No. EL/3.2.30

MODIFICATION SHEET NO. ELRS/MS/0269

**MODIFICATION IN THE AIR SUPPLY LINE TO ENSURE EFFECTIVE
OPERATION OF THE OIL PUMP (PHGR) FITTED WITH THE OIL PUMP
DEVICE (OPD) IN THE ADTRANZ MAKE TAP CHANGER NO 32**

SCHEMATIC DIAGRAM OF
OIL PUMP & OIL PUMP DEVICE
IN ADTRANZ TAPCHANGER
NO. 32

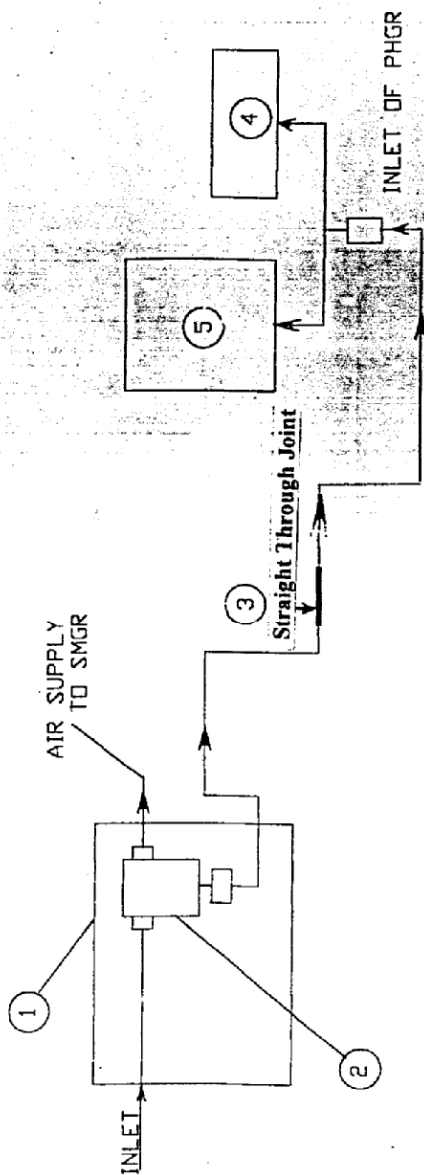
- 1.3 The modified air pipe line arrangement to be adopted is shown in RDSO Drg. No. SKEL-4539.
- 1.4 Follow specific pre-commissioning instructions for EVPHGR, air pipe line, PHGR and oil pump device as laid down in this modification sheet.

- 2.0 WORK TO BE CARRIED OUT**
- (a) **Removal of 'T' Joint**
- 2.1 Remove 'T' joint in the air pipe line between EVPHGR and inlet to PHGR.
- 2.2 Instead provide a straight through joint at the location where 'T' joint exists (Ref. Drg. No. SKEL-4539).

Straight through joint for replacement of the 'T' joint as per RDSO Drg. No. SKEL-4539.
